Product Update Memo

CHIP DIODES

Product Change Notice Bourns® CD1206-S01575 Chip Diode Package Change

Current Package

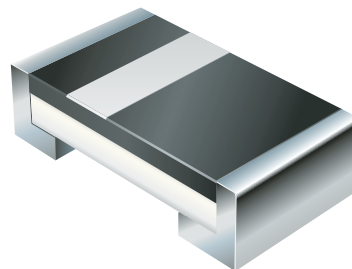
Over the past twelve months, Bourns has incurred large material cost increases for the packaging of chip diode products, especially the substrate and copper and gold materials. In addition, lead times for raw materials have increased. To ensure continued product delivery, competitive pricing and support to our customers on the CD1206-S01575 device, Bourns will initiate an immediate product change from the BT substrate package to the ceramic package assembly on the switching diode device.

Electrical specifications will remain unchanged. Bourns will offer the new replacement CD1206-S01575 device at the same price as the previous version. See the Bourns Price Book for more details.

Effective immediately, no further orders for the old package format will be accepted. On all new orders, the new ceramic type package will be used for the CD1206-S01575 model. The product [data sheet](#) with detailed specifications can be viewed on the Bourns website at www.bourns.com. Samples are available upon request.
